Re: **The Markets at Bent Grass
Roundabout Analysis Memorandum**

The intent of this memorandum is to respond to a comment provided by El Paso County on The Markets at Bent Grass Master Traffic Impact Study (MTIS) completed in March 2026 by SM Rocha. The comment provided by El Paso County stated “provide roundabout parameters table and exhibits including fastest path speeds and differentials, dimensions, widths, view angles, etc. Discuss specific needs and examples with staff. Include design vehicle and WB-67 tracking exhibits.” The following memorandum will address this comment with a roundabout analysis provided herein.

The Markets at Bent Grass
El Paso County, Colorado
(EPC No.: CR-26-01, SP-26-02)

ROUNABOUT LAYOUT

NORTHBOUND VEHICLE TRACKING PATH (WB-67)
SCALE: 1"=60'

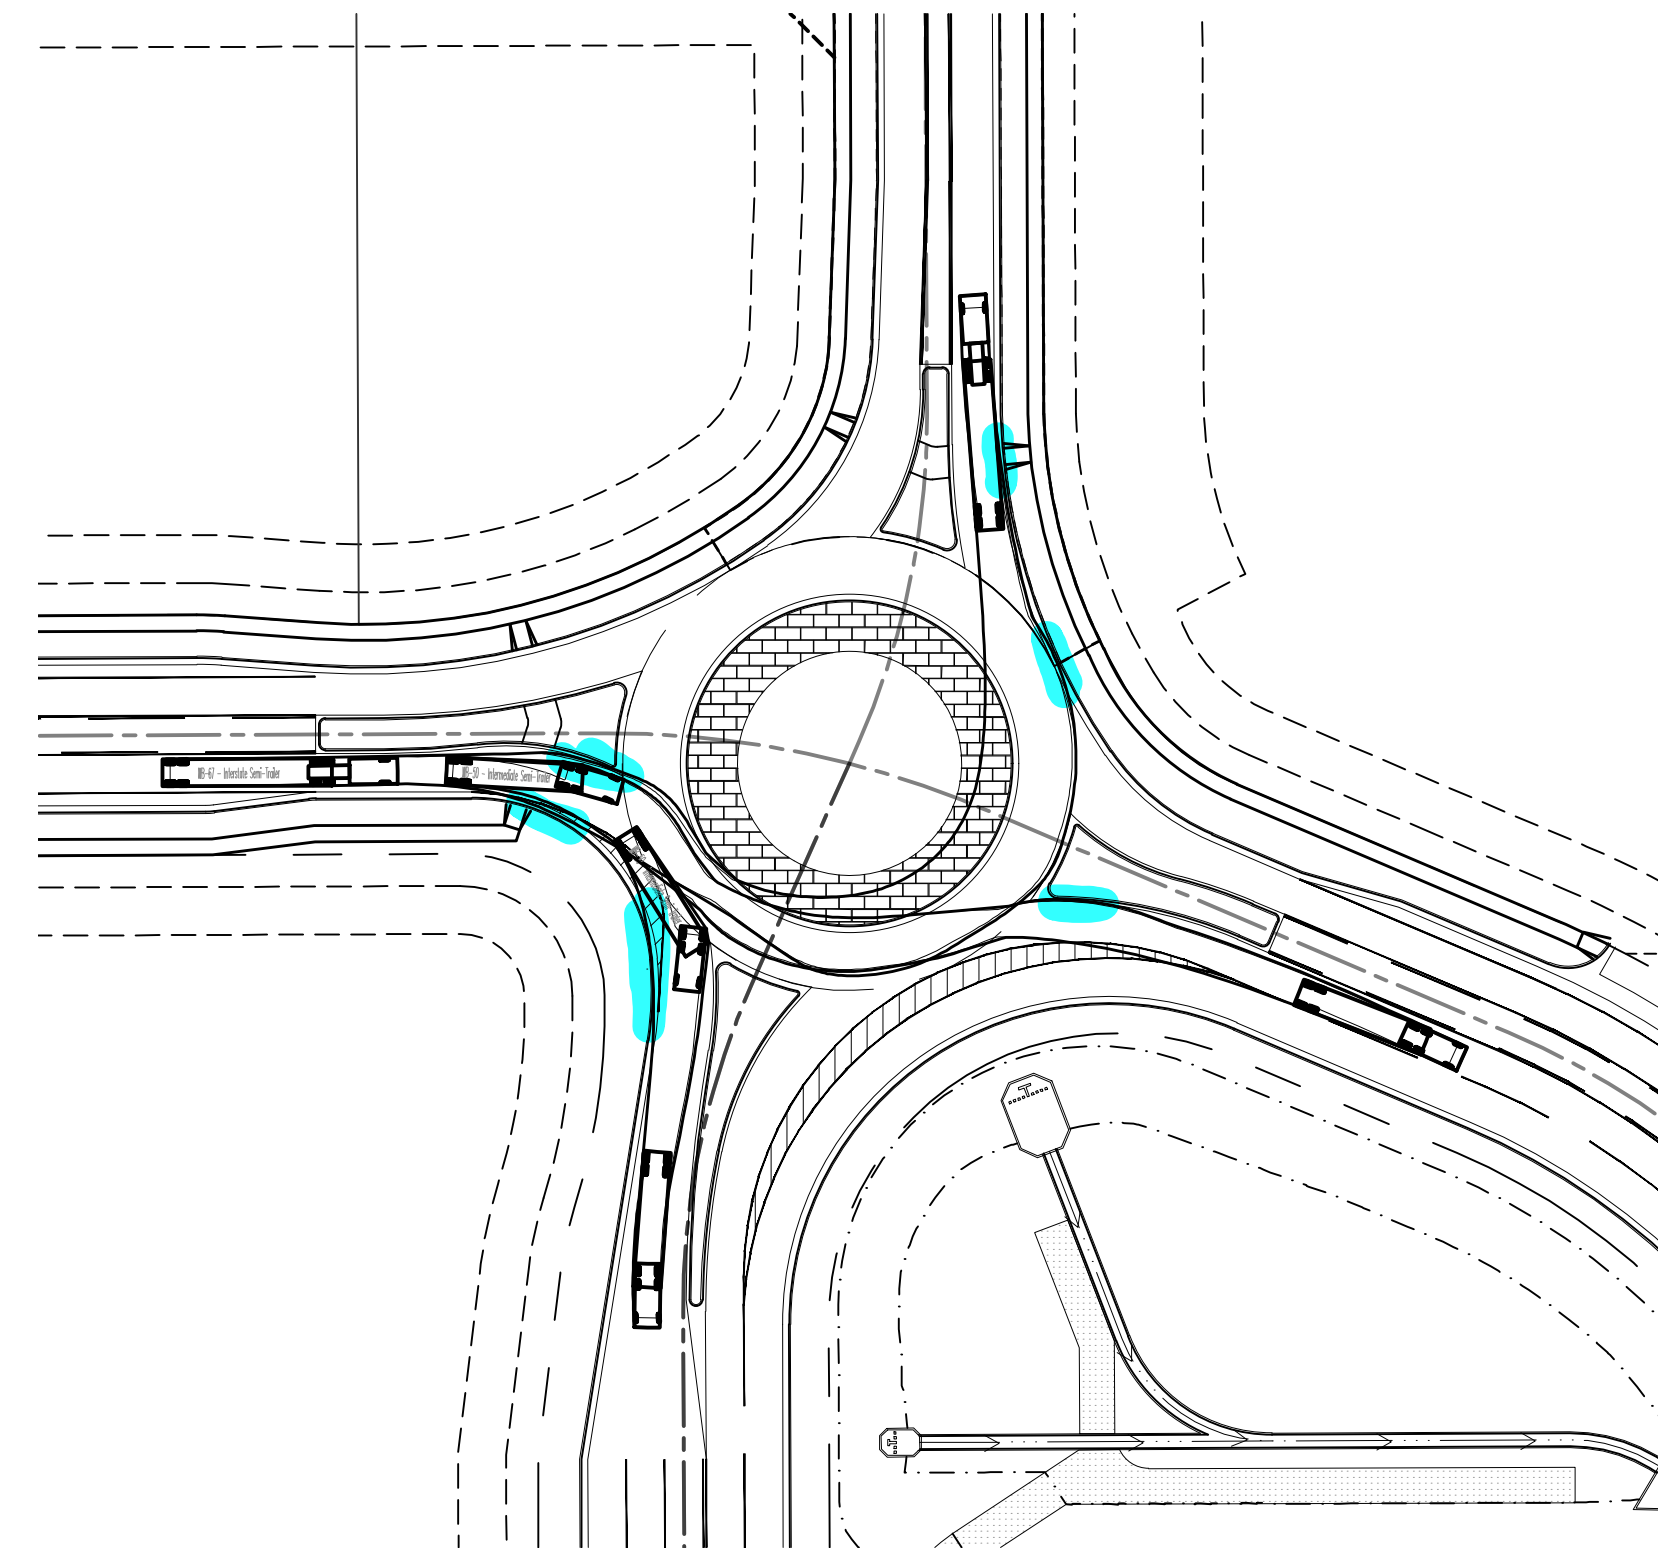
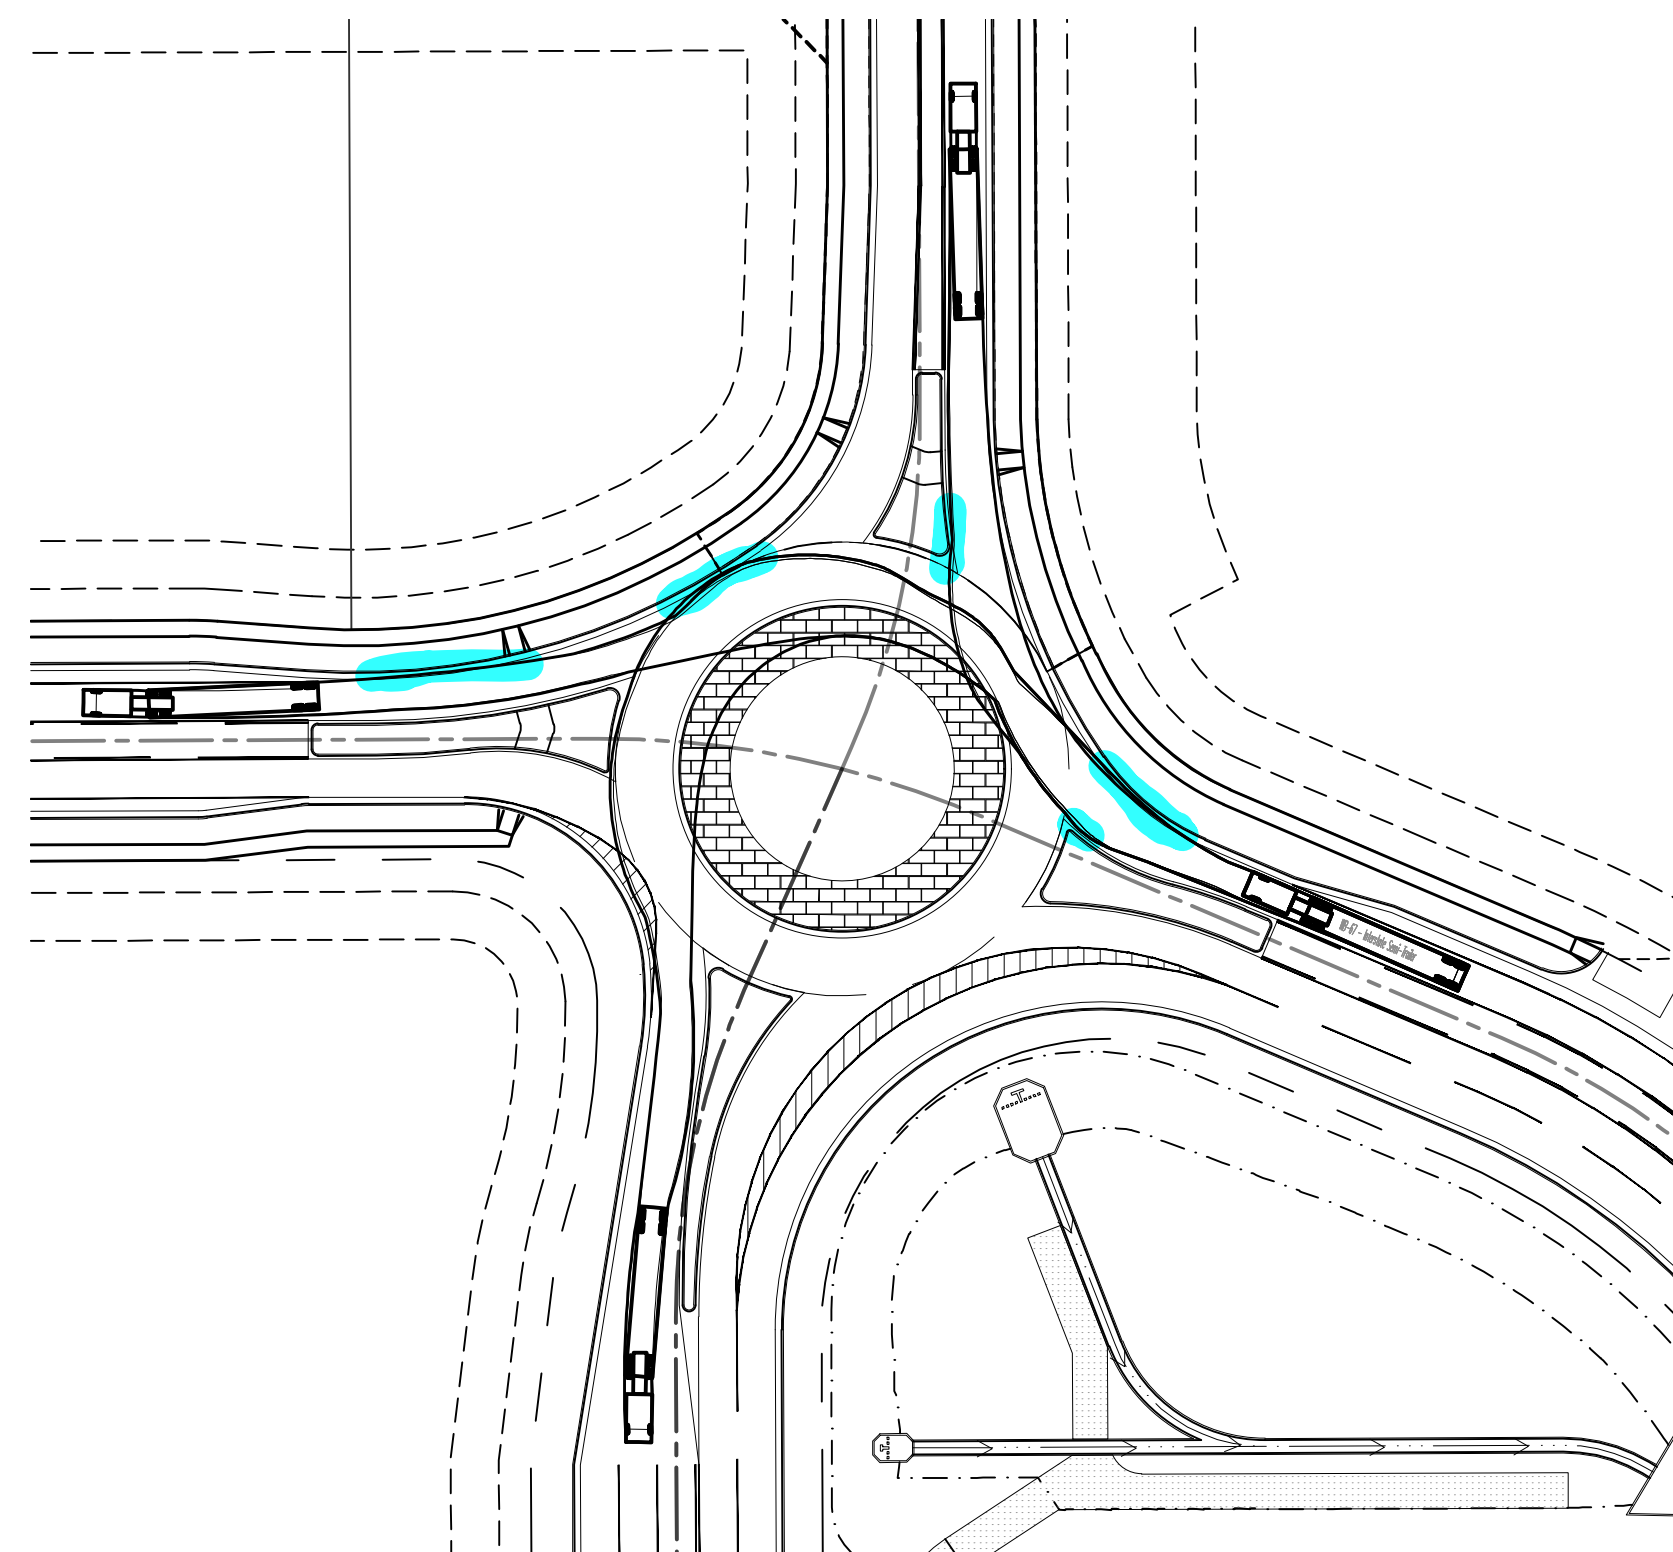
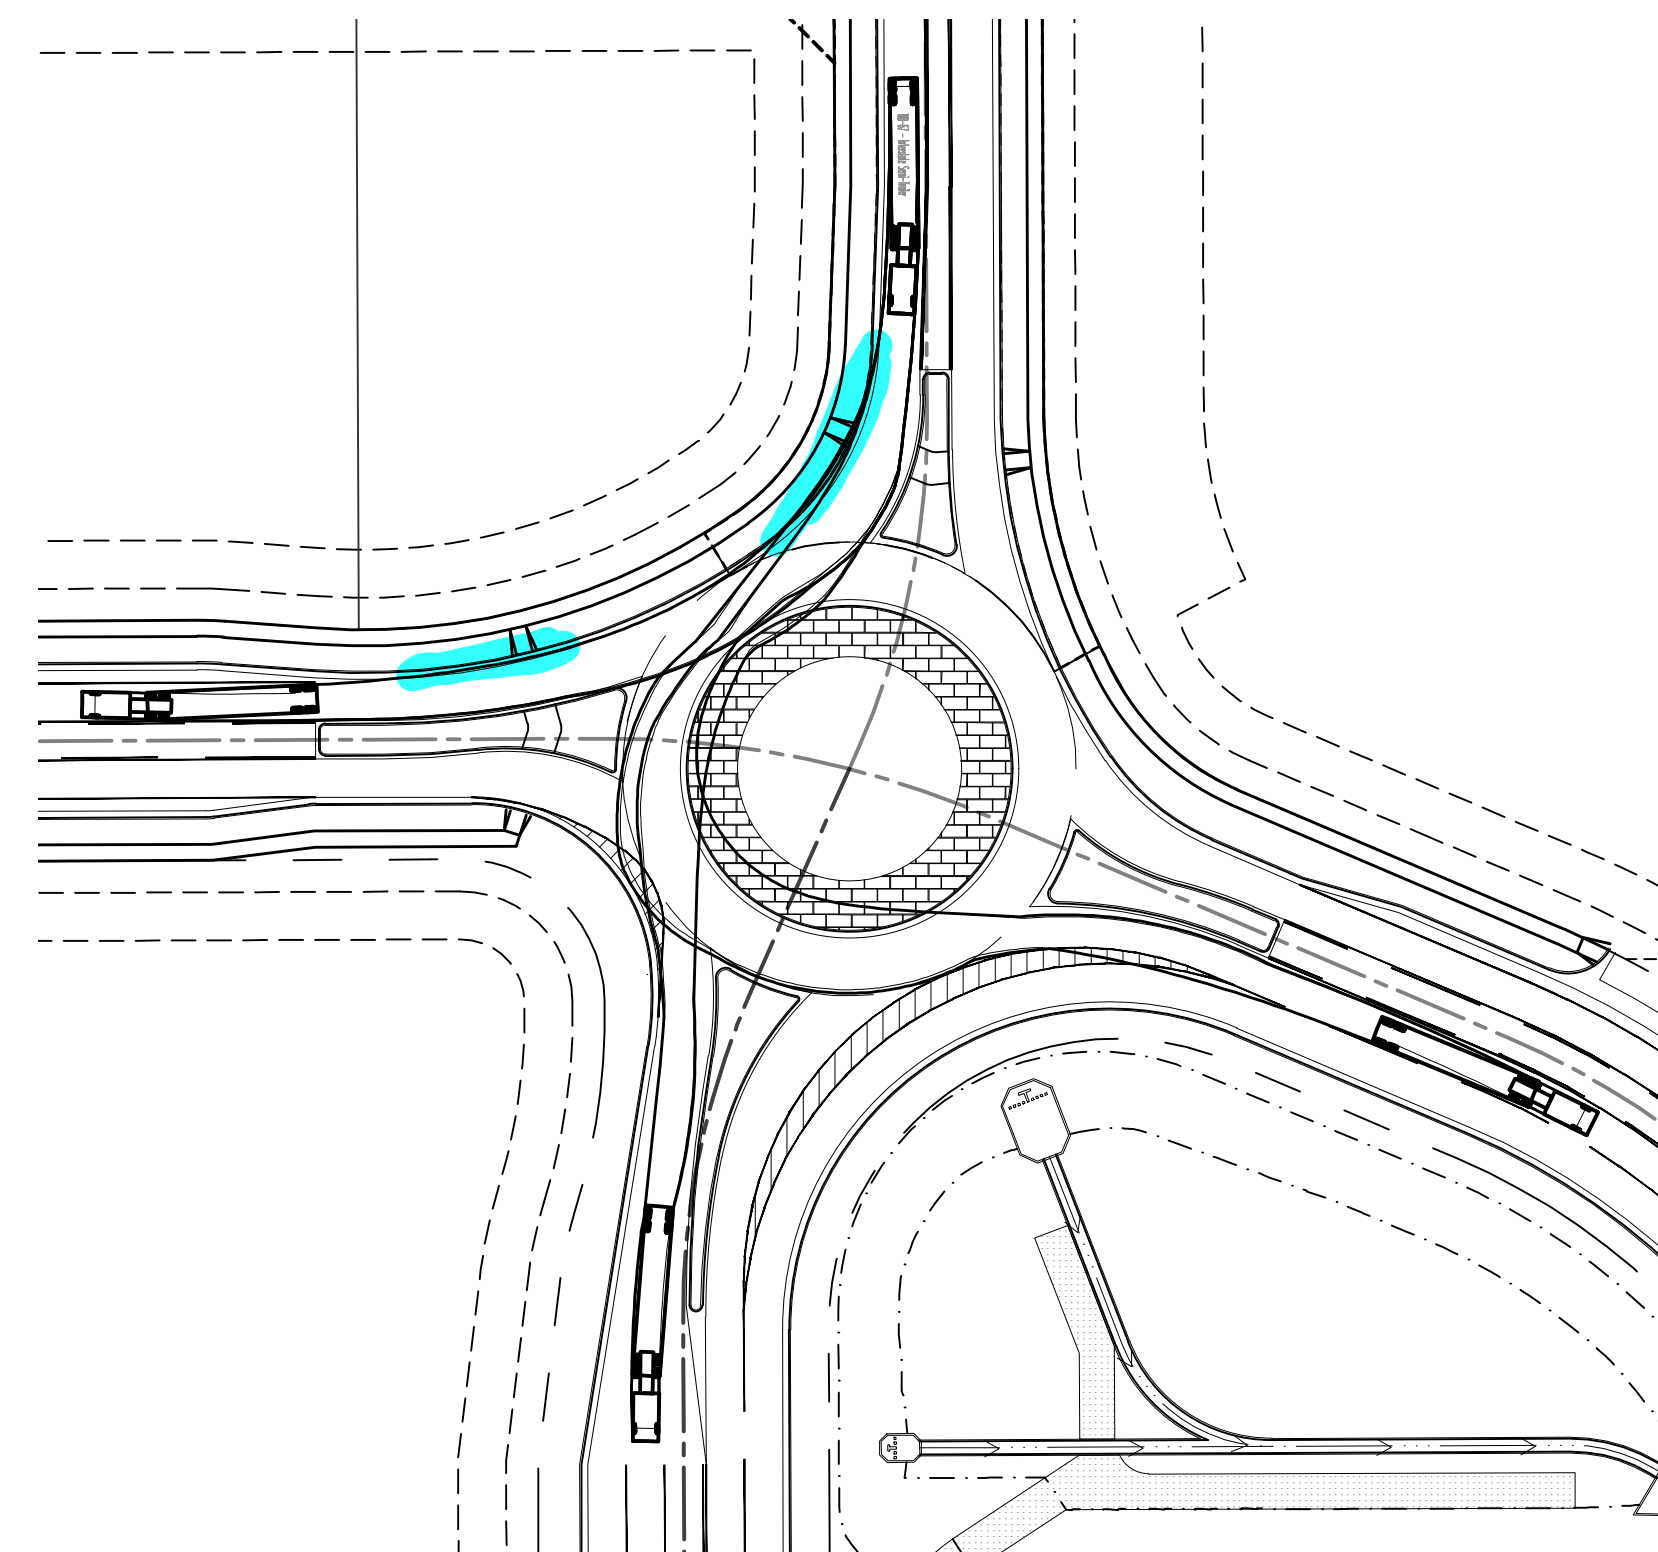
Highlighted areas appear not to meet tracking offset requirements and need to be adjusted.
